Date: 2/25/04

To: T10 Committee (SCSI)

From: George Penokie (IBM/Tivoli)

Subject: SAS UML Corrections

Figure 7 — Phy classes

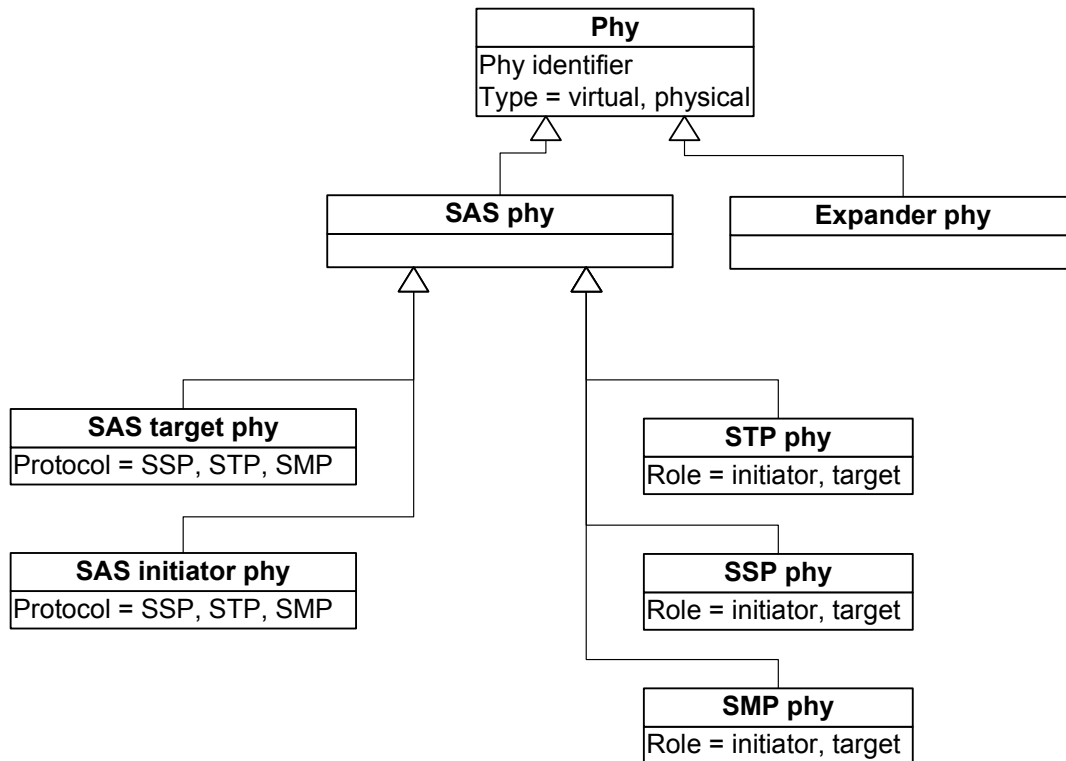
Figure 7 expands the phy class showing the relationships between the following classes:

- a) phy, SAS phy;
- b) SAS phy;
- c) SAS initiator phy;

- d) SAS target phy;
- e) SSP phy;
- f) STP phy;
- g) SMP phy classes; and
- h) expander phy.

Figure 9 — Port classes

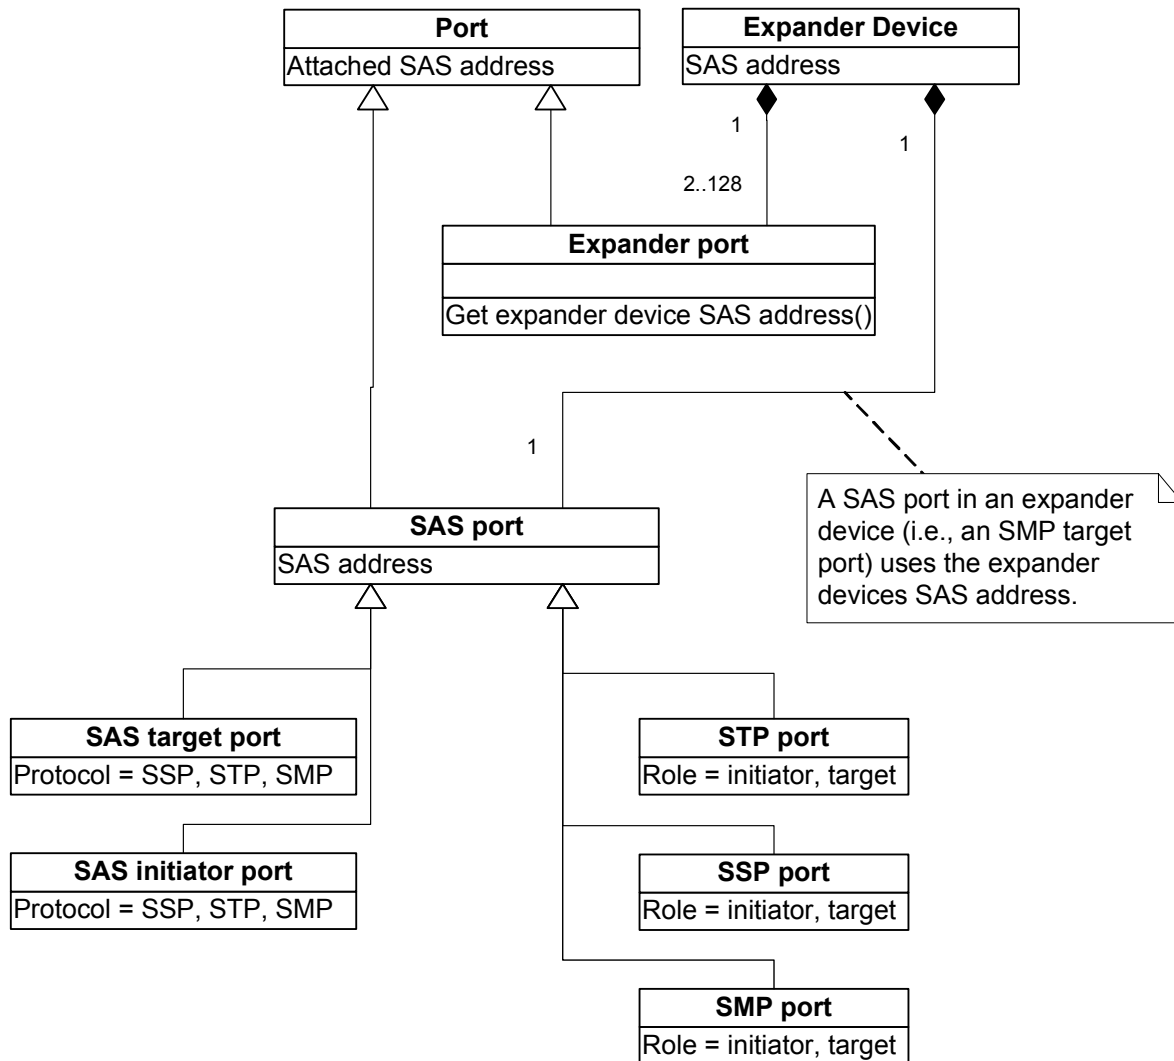
Figure 9 expands the port class and expander class to show the relationships between the following classes:

- port;
- expander device;
- expander port;
- SAS port classes;
- SAS target port;
- SAS initiator port;
- STP port;
- SSP port; and
- SMP port.

Figure 11 — Expander device classes

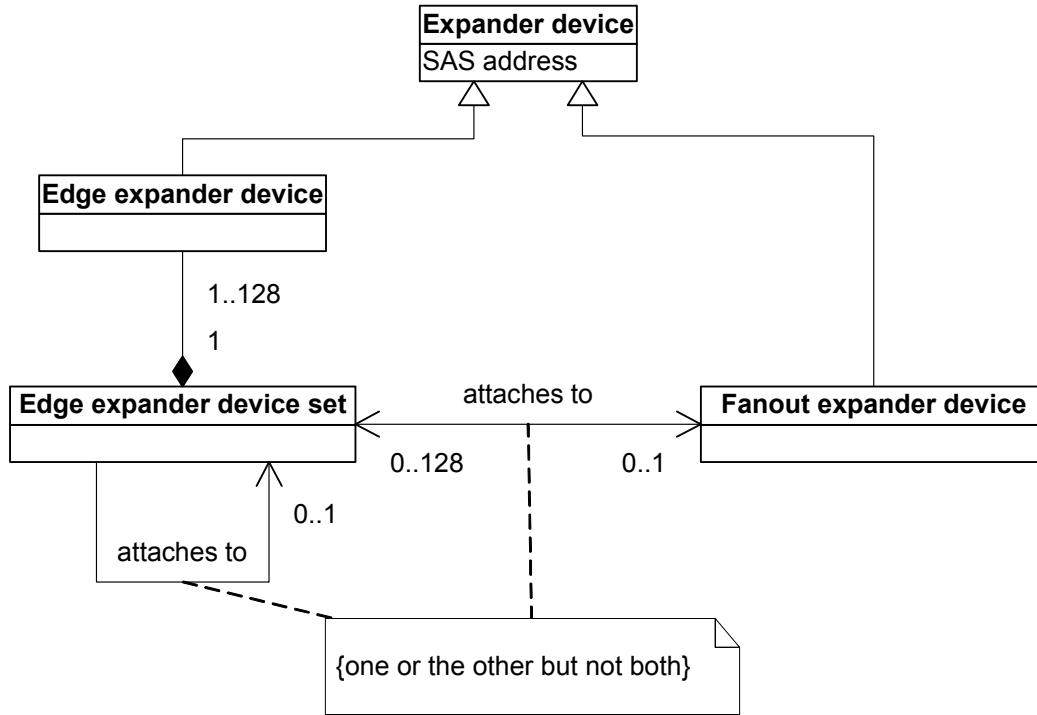
Figure 11 shows the expander device classes.

Figure 12 — State machines for SAS devices

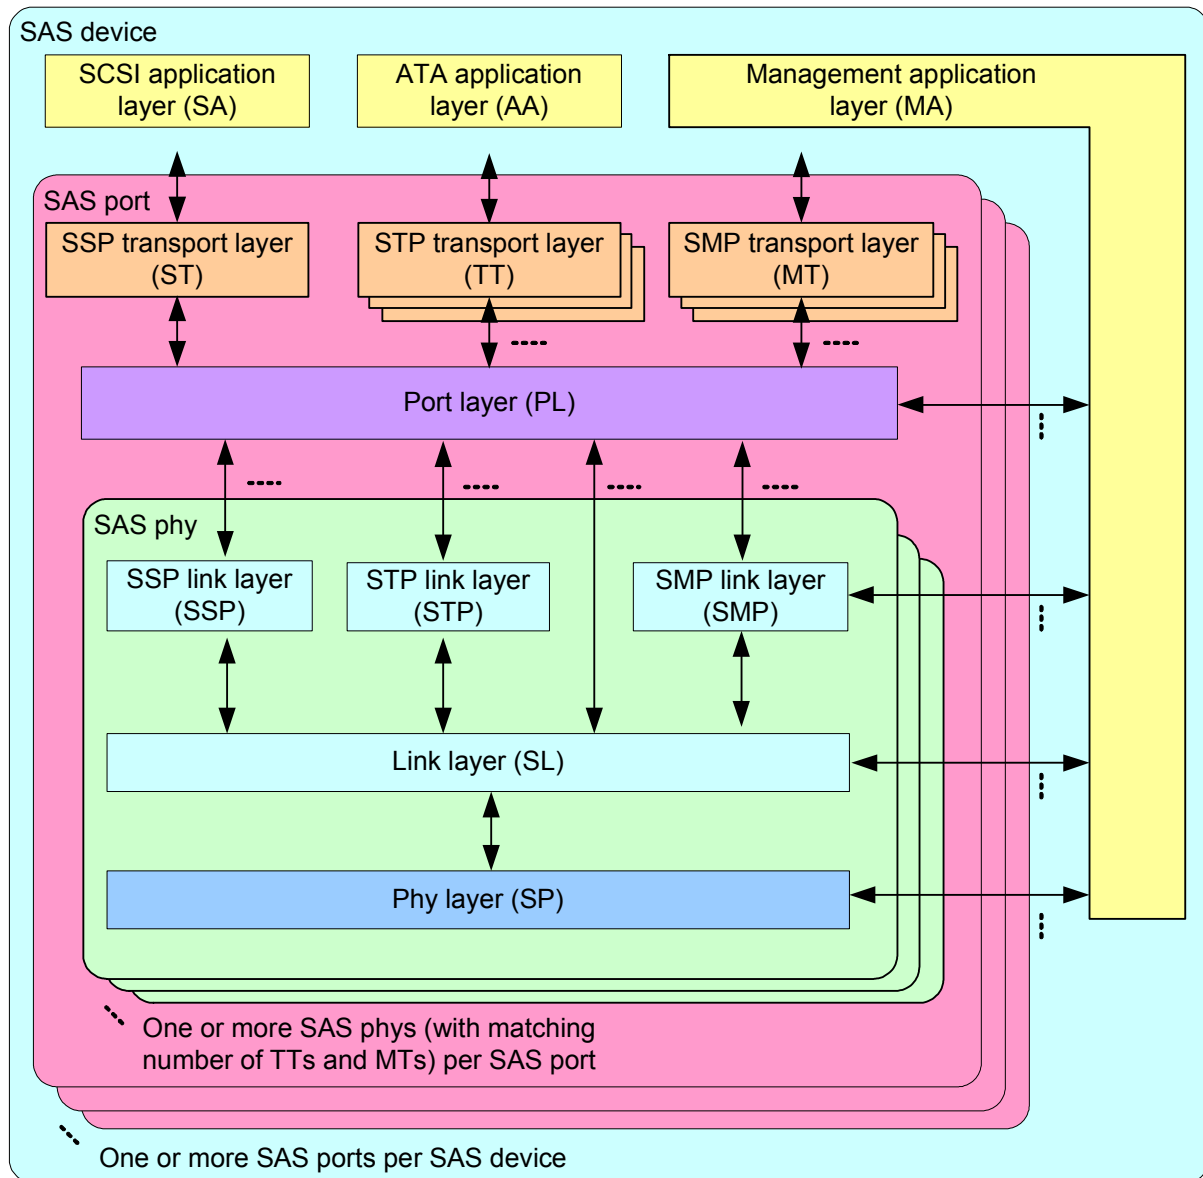
Figure 12 shows the state machines for SAS devices, their relationships to each other and to the SAS device, SAS port, and SAS phy.

Figure 13 — State machines for expander devices

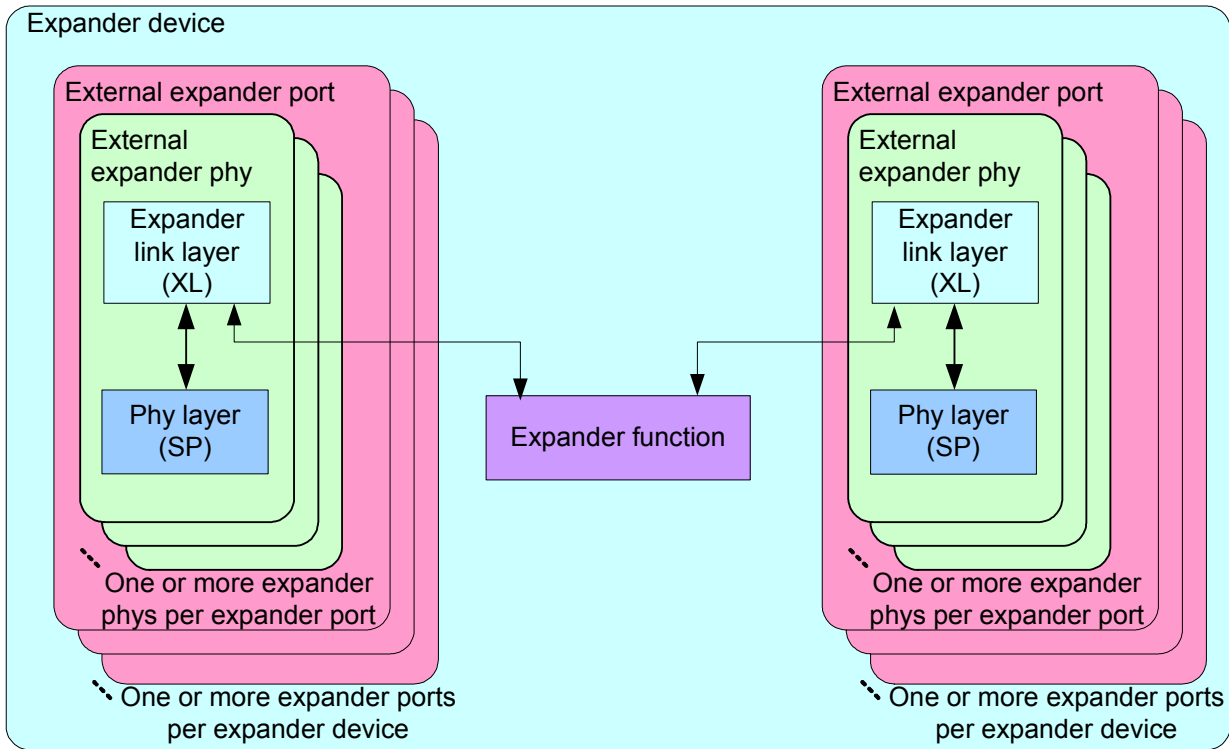
Figure 13 shows the state machines for expander devices, their relationships to each other and to the expander device, expander port, and expander phy. Expander function state machines are not defined in this standard, but the interface to the expander function is defined in 4.6.6.

Figure 14 — State machine and SAS device, SAS port, and SAS phy classes

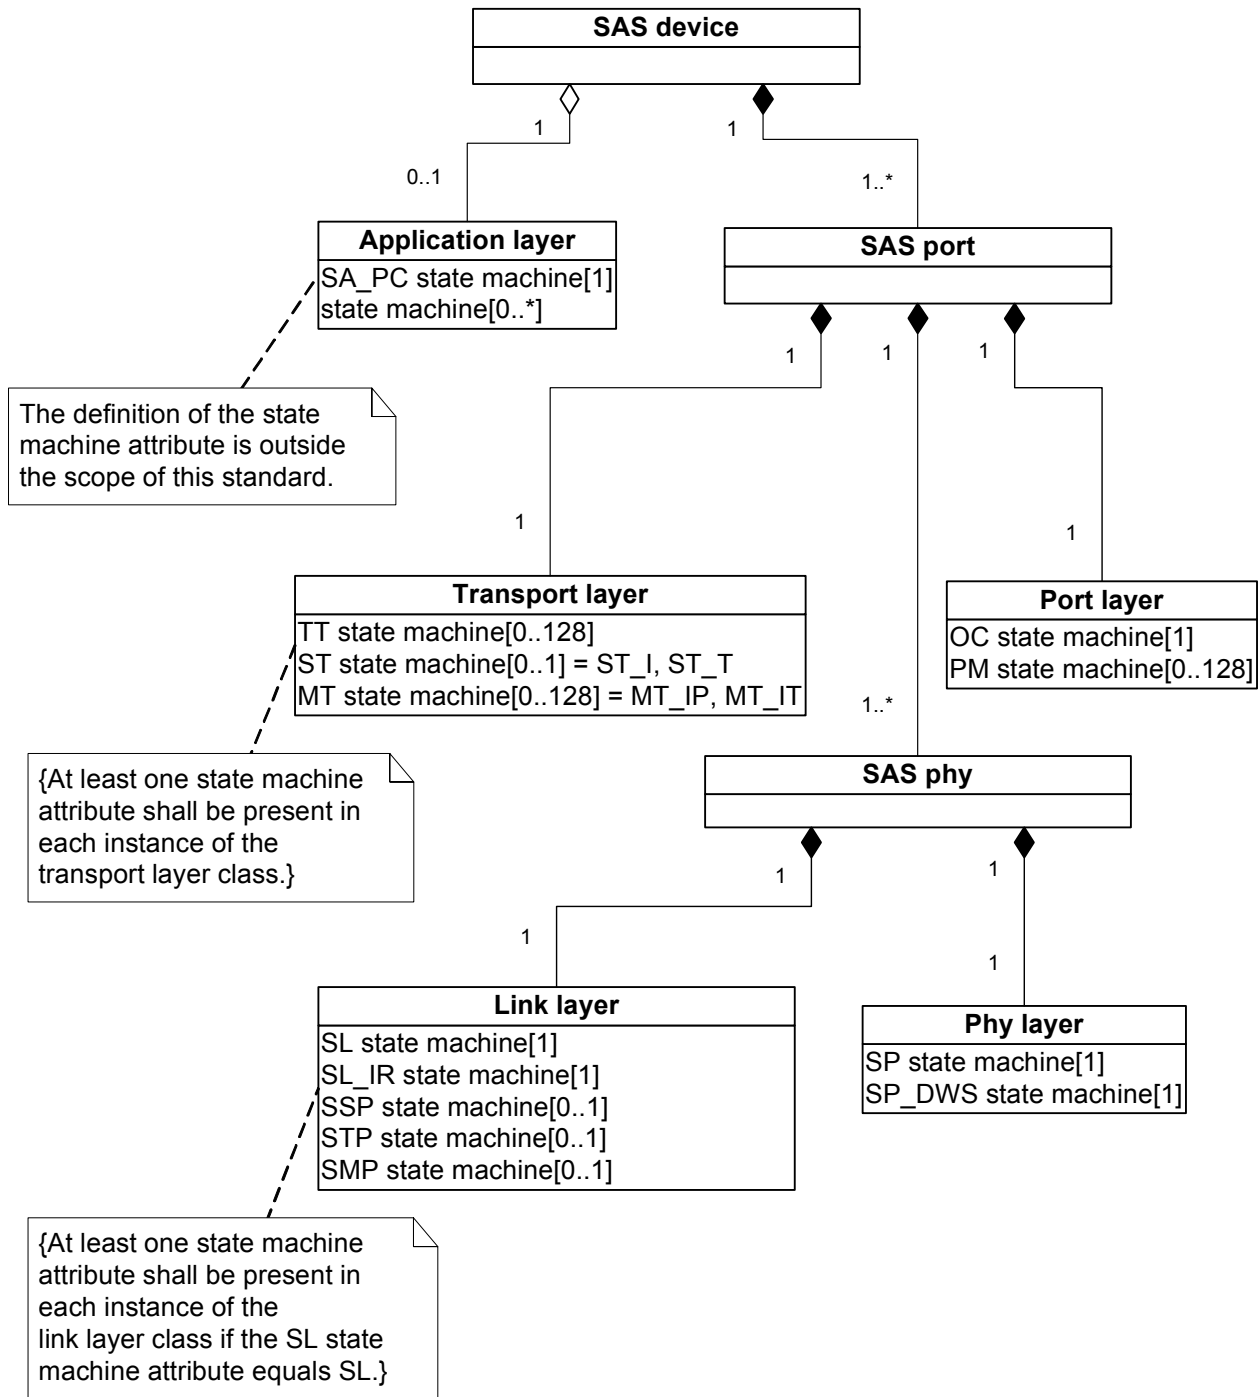
Figure 14 shows which state machines are contained within the SAS device, SAS port, and SAS phy classes.

Figure 15 — State machine and expander device, expander port, and expander phy classes

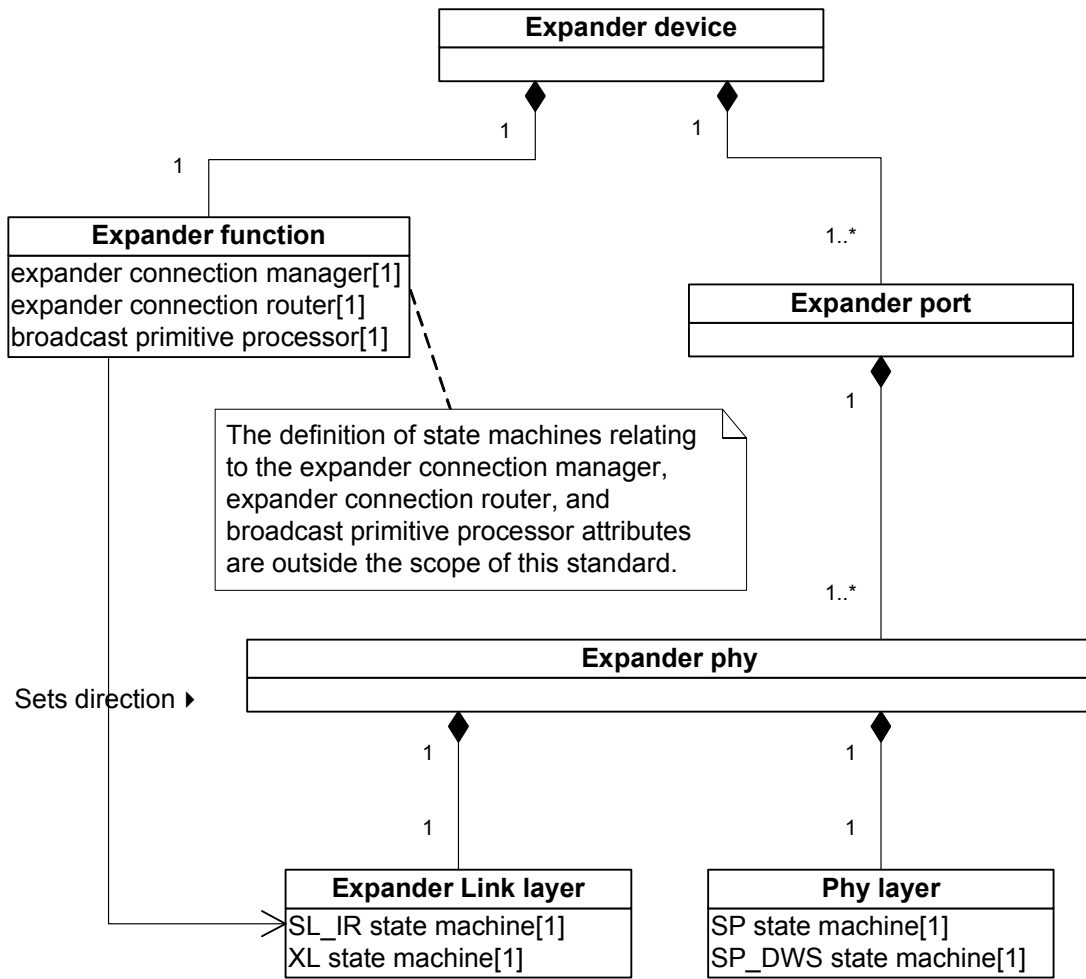
Figure 15 shows which state machines are contained within the expander device, expander port, and expander phy classes.
